City of Stuart

**A G E N D A**  
**STUART COMMUNITY REDEVELOPMENT/HISTORIC PRESERVATION**  
**BOARD**

**TO BE HELD AUGUST 4, 2020 AT 4:00 PM**  
**COMMISSION CHAMBERS & ZOOM TELECOMMUNICATIONS**  
**121 S.W. FLAGLER AVE.**  
**STUART, FLORIDA 34994**

1. Resolution 96-2020: 315 Osceola Street MUCCU
2. 2nd Presentation - CDBG Application and Housing Assistance Plan
3. 2449-2020 Sailfish Cove UPUD
4. Ordinance 2439-2020: Lone Palm Property Investments, LLC Future Land Use Map Amendment, Rezoning and MUCCU
5. R97-2020 Walton Building (33 degrees)
6. Presentation on Contemporary Art Exhibit in Gazebo Park
7. Resolution No. 07-2020 CRA - Tentative CRA Budget for FY 2021

SAILFISH COVE  
CITY OF STUART, FLORIDA  
PAVEMENT MARKING AND LAYOUT

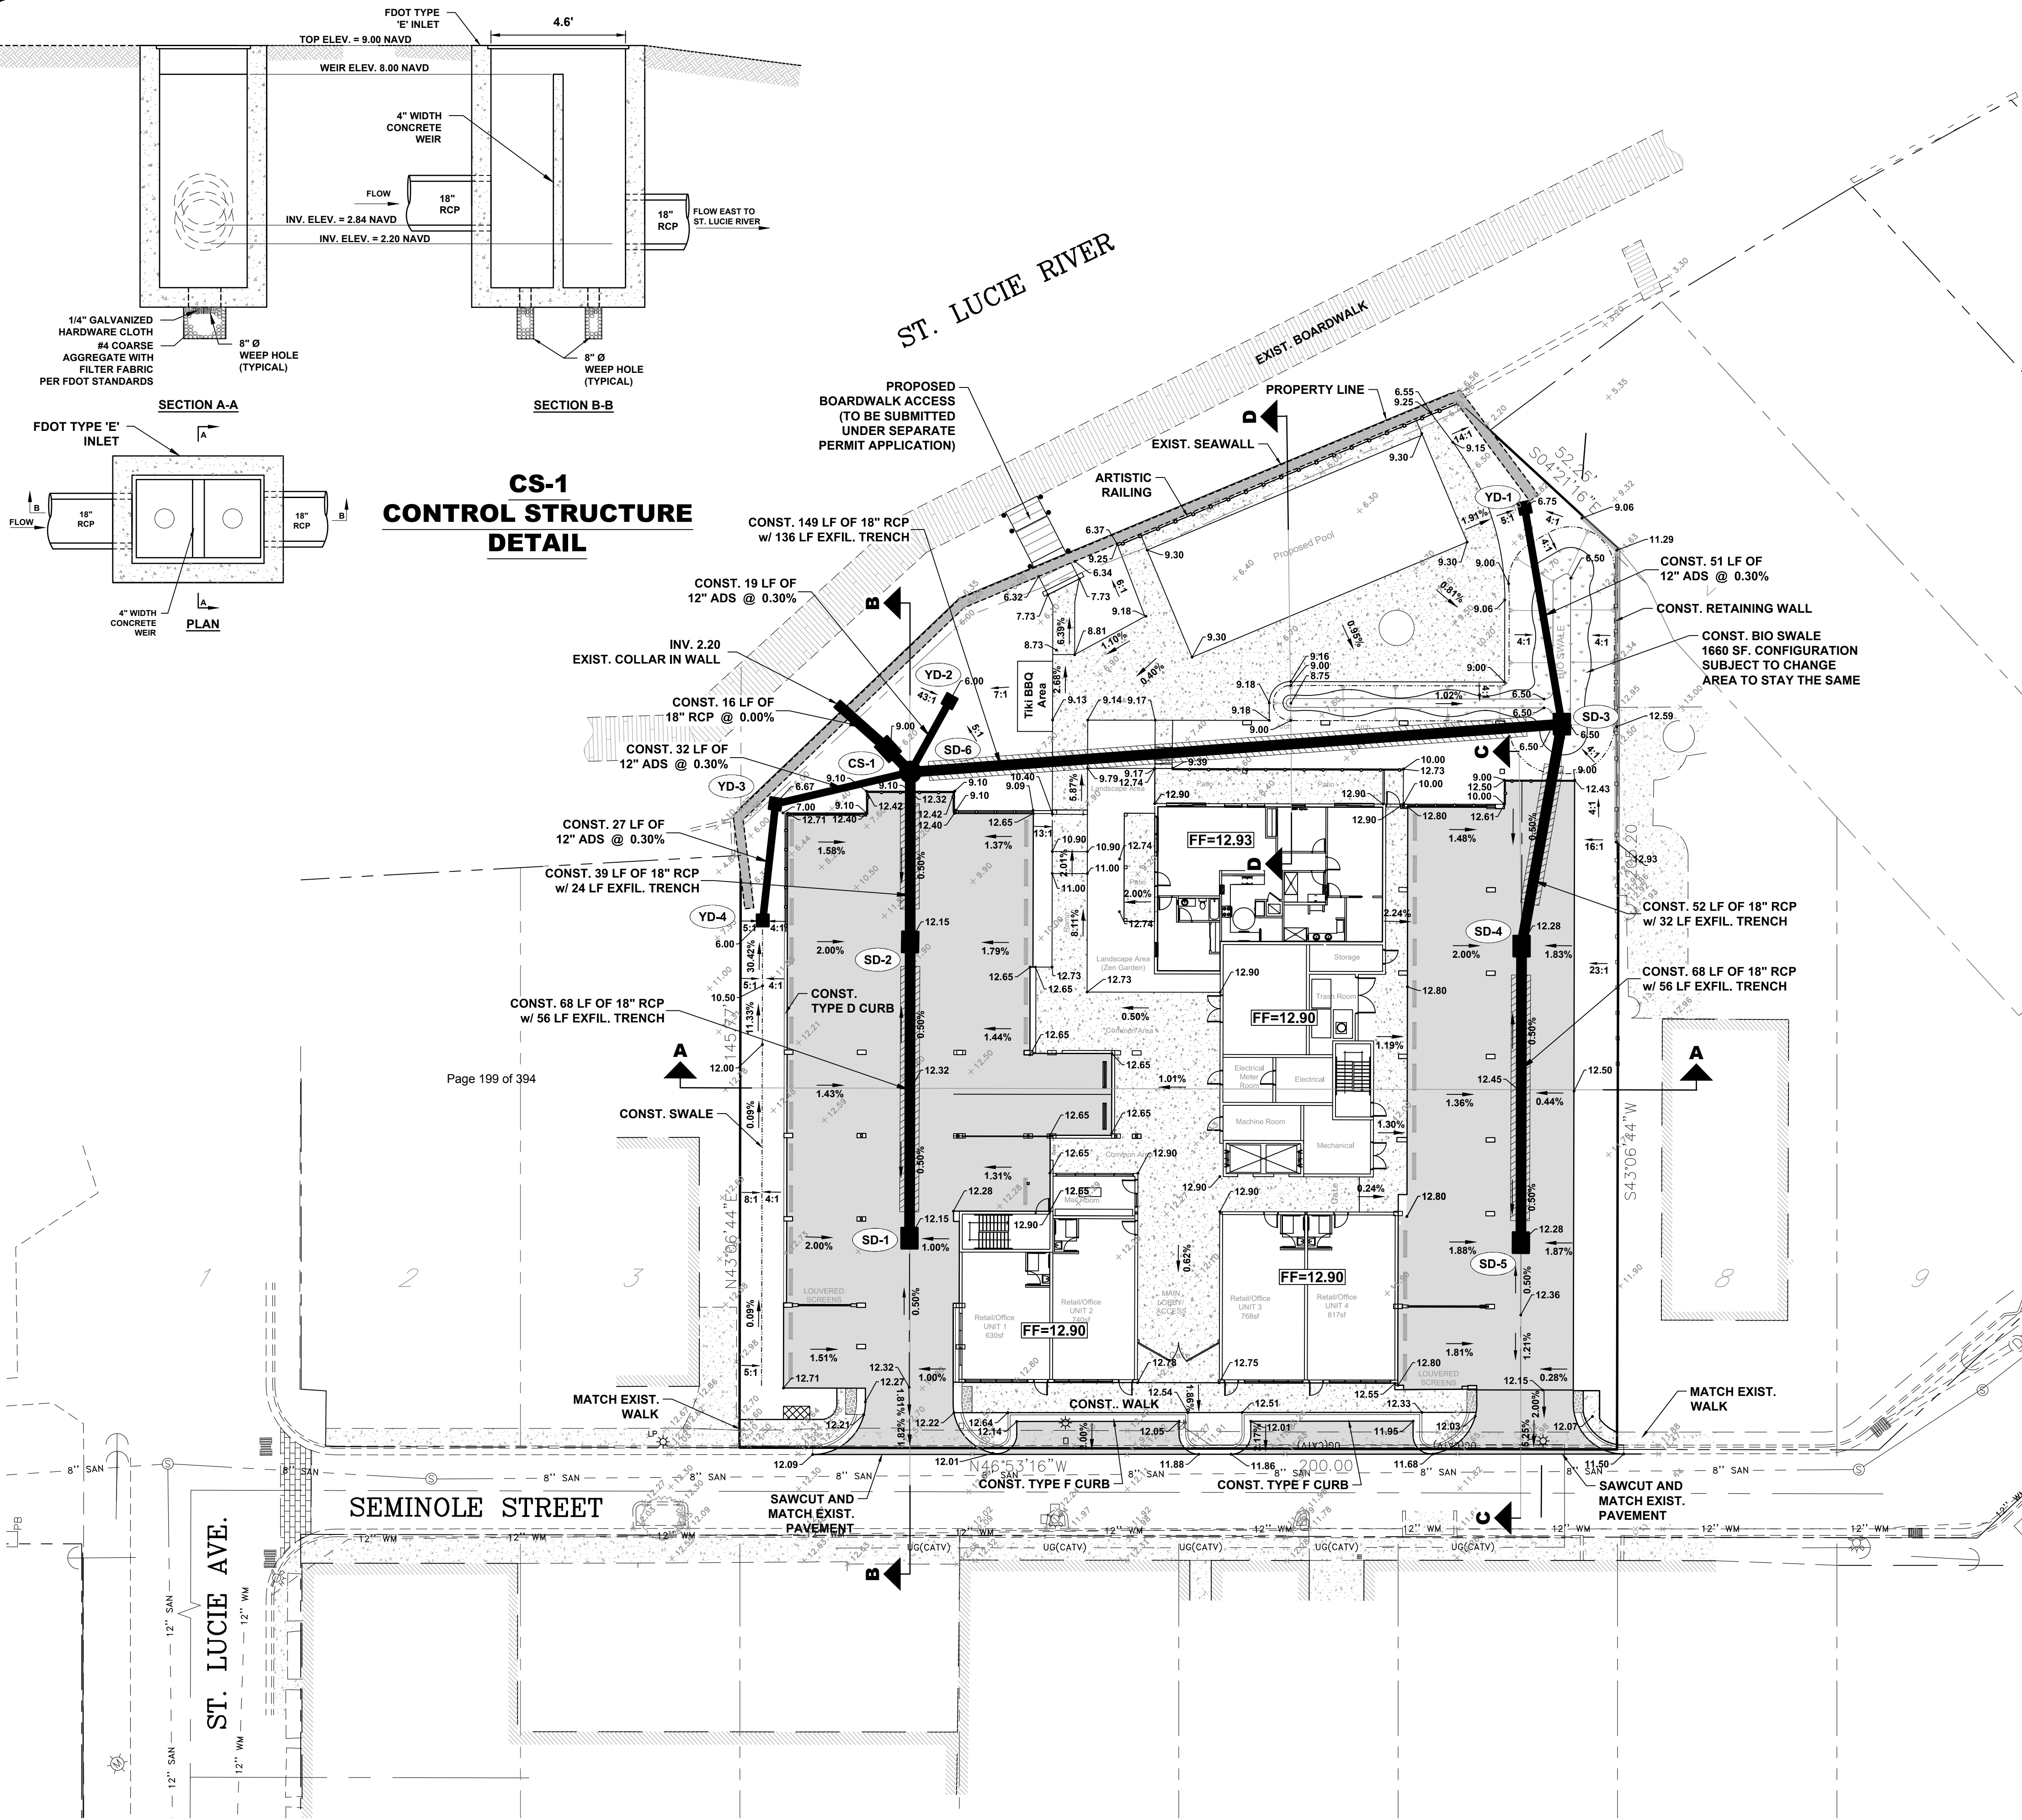
2. Several retaining walls are identified in the Section on Sheet 6 but are not called out on Paving and Drainage Plan Sheet 5.

**Response:** *The Paving and Drainage Plan Sheet 5 has been updated to include the retaining walls identified in the Section on Sheet 6.*
